Re: Reliability and Resource Adequacy Study Review – Root Cause Analysis Report for the L'Anse au Diable Grounding Station Phase 2 Breakwater

The results of this analysis, completed by Tiller Engineering Inc. ("TEI"), are provided in Attachment 1, "Labrador Island Link Limited Partnership Root Cause Analysis Report – L'Anse au Diable Grounding Station Phase 2 Breakwater" ("TEI Report"). TEI's review of the site conditions and design considerations determined that the root cause of the damage is the breakwater's crest not being high enough to protect against extreme site conditions. TEI recommended upgrades to mitigate the impact of significant wave events on the breakwater, better enabling it to protect the electrode site.

Labrador Island Link Limited Partnership Root Cause Analysis Report

L'Anse au Diable Grounding Station Phase 2 Breakwater

Figure 1.3 Typical Design Section

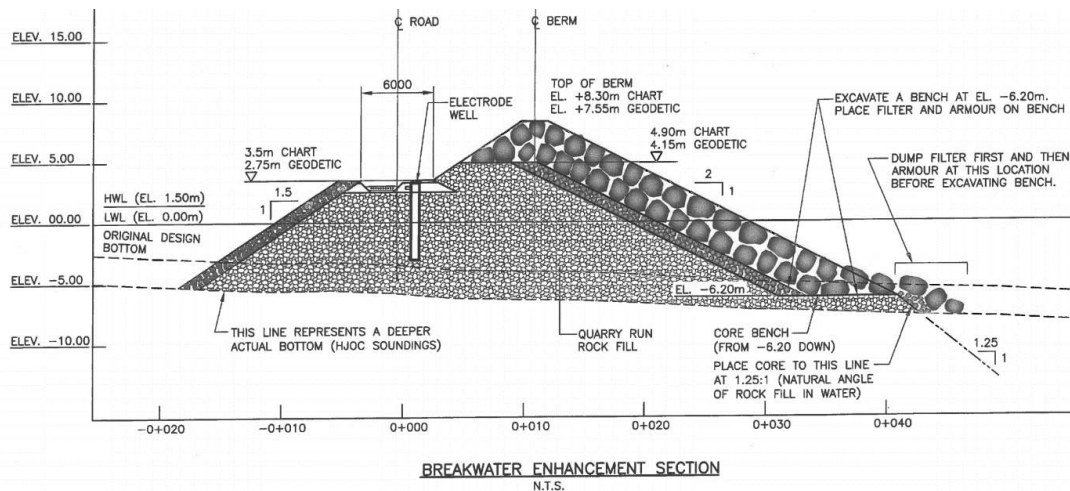
TEI evaluated the root cause of the washouts by reviewing the original design of the breakwater. Rubble mound breakwaters such as the one at L'Anse au Diable are designed with an armor stone size and a geometry to resist erosion from wave and ice action that are specific to that site. The geometry of a typical section in Figure 1.3 is governed by the design wave and a design water level. After a review of presented design documentation, it would appear that the breakwater at L'Anse au Diable is designed for a design wave with a 100 year return period, and a design water level with a 1 meter allowance for sea level rise.

The Shore Protection Manual (SPM), US Army Corp of Engineers, 1984 is the referenced standard for breakwater design. The SPM discuss two main types of design criteria for breakwaters; structural stability of the breakwater and functional performance but does not offer firm guidance with respect to values, leaving it with the designer to establish these based on economics. Design criteria from client reference documents further specified the breakwater should be designed to withstand the "expected worst case" site conditions.

The L'Anse au Diable breakwater was designed using a design wave (H_s) with a 100-year annual exceedance probability. The offshore design wave chosen from the MSC50 data for the site was 6.1m, after transposing this to the breakwater site we see a wave reduction factor of 0.67 to an inshore design wave of 4.1 meters. At no point in the design documents is the 100-year design wave period mentioned or a wave height/period combination to represent a design condition suitable to a worst-case scenario. The breakwater was also with a design water level of 1.5 meter, with an additional 1 meter added on for sea level change. There is no documentation that extreme water levels associated with a storm surge were taken into account, however this may have been included in the delft 3D/SWAN model. It is these considerations that lead to the geometric design of the L'Anse au Diable breakwater as seen in table 4.4.

Figure 4.2

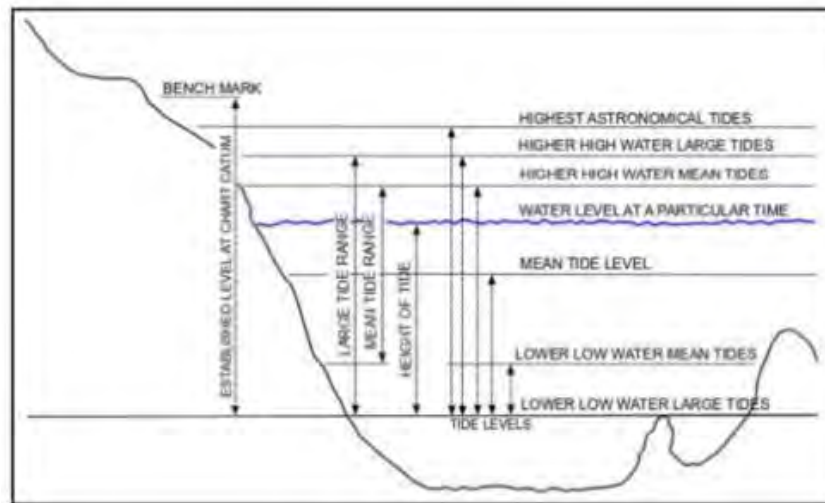
Another direct parameter for a breakwater's design is the design water level, which can vary due to many different factors including tides, storm surge, sea level rise and other seasonal variations. There is no direct discussion in the received documents regarding what water level should be used for the breakwater design but there is a mention of a predicted high-water level between 1.4 meters and 1.6 meters. In the received design drawings, it is indicated a water level of 1.5m is used in design.

In addition to 1.5m high water level a one (1) meter increase for the allowance of sea level rise due to climate change was requested to be used by the client in Nalcor Document No. MFA-SN-CD-6300-CV-DC-001-01. A 1 meter increase in sea level rise is considered a reasonable assumption in the strait of Belle Isle over a 100-year period.

Figure 5.1 Section D-D Cross Section

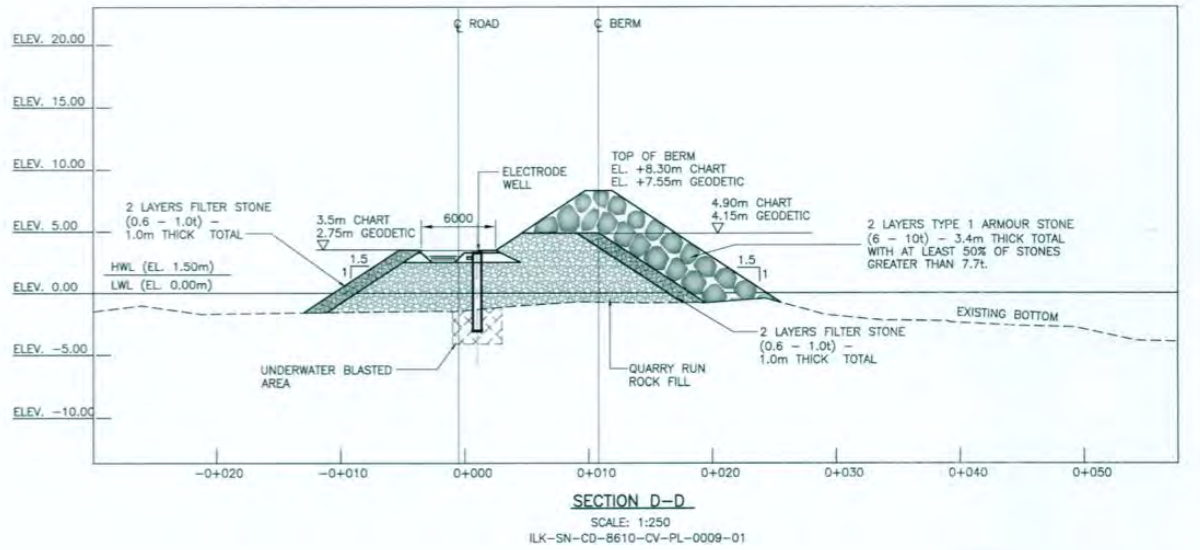
Design documents include a site plan as well as cross sections at various points along the breakwater. Elevations on the design drawings include height for core, filter, and armor stones; as-built elevations are to be as close as possible to these elevations as these elevations are the determined heights for the breakwater to resist wave action.

When reviewing as-built elevations it appears that points along the breakwater have lower elevations than design. The low elevations are not limited to individual layers but are present in the core, filter, and armor stones. In Figure 5.1 the design section D-D is shown with design elevations. Figure 5.2 shows the as-built elevations in the same location as section D-D. When comparing the two section elevations it is apparent that the filter stones and armor stones did not reach the required design height. Filter stones on the seaward side of the breakwater are designed to reach a height of 4.15 meters with reference to the geodetic datum. However, the as-built survey indicates that it extended to approximately 3.2 meters. Elevation differences are not limited to these sections but appear to be present in most of the sections provided. The table below shows areas where as-built elevations do not appear to match with design elevations.

Figure 6.2

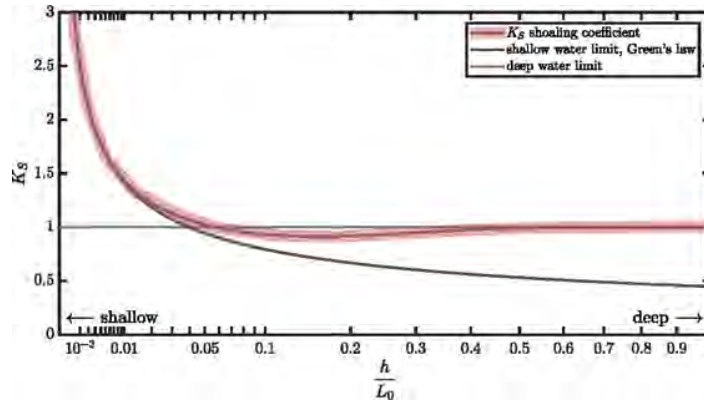
As the deep-water waves approach the shoreline, they will get smaller as the water depth decreases. Without having the capacity to complete a wave study with a more accurate numerical software like Delft 3D/SWAN or similar we can transpose the wave with the shoaling coefficient and refraction coefficient which will reduce the wave height as it approaches the coast. The waves shoaling coefficient can be approximated from the below Figure 6.2 from the SPM1984.

The deep water waves approaching the shore will also be reduced if the wave approach the shore at an angle, an effect known as refraction. The amount of wave refraction is further a function of the seaward seabed slope. For the L'Anse au Diable site, the offshore wave refracts approximately 34 degrees from the dominant wave direction, with a seabed slope of 4 to 5 %.

Using tables from the SPM1984 and making preliminary estimates we can get a shoaling coefficient (K_s) of 0.92 and a refraction coefficient (K_r) of 0.96 for an overall reduction factor of 0.88.

Figure 1.2 Typical Design Section (2015)

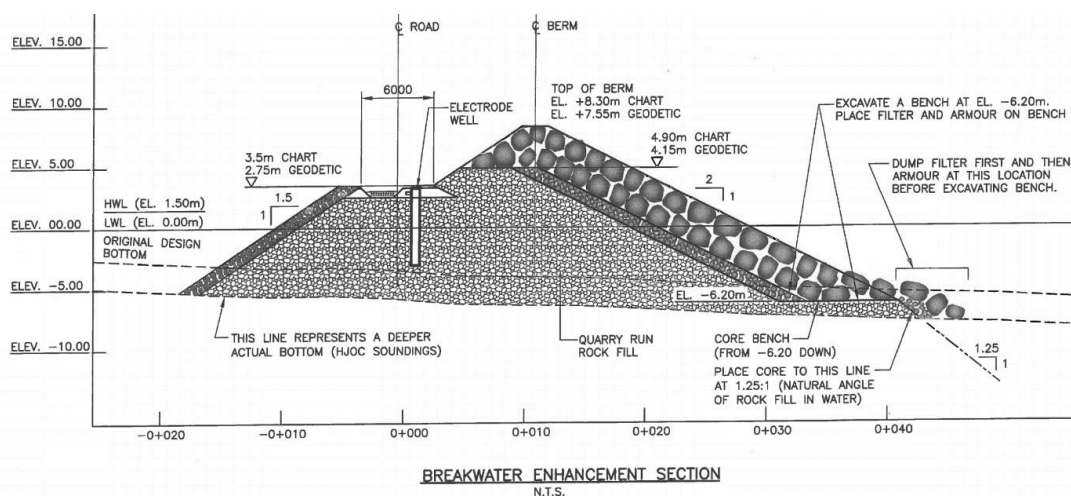
From a design perspective, the geometry of the typical section in Figure 1.2 is governed by the design wave and the design water level. The general guidance provided in the SPM is to determine the appropriate offshore design wave condition, then transpose that wave to the shoreline while considering shoaling, refraction, etc. effects that change the design wave. The offshore wave condition is defined by a wave height and period, although there is a full spectrum of height/period combinations during any storm event. The design water level is a function of tides, but also surge related to storm winds, hurricanes, etc.
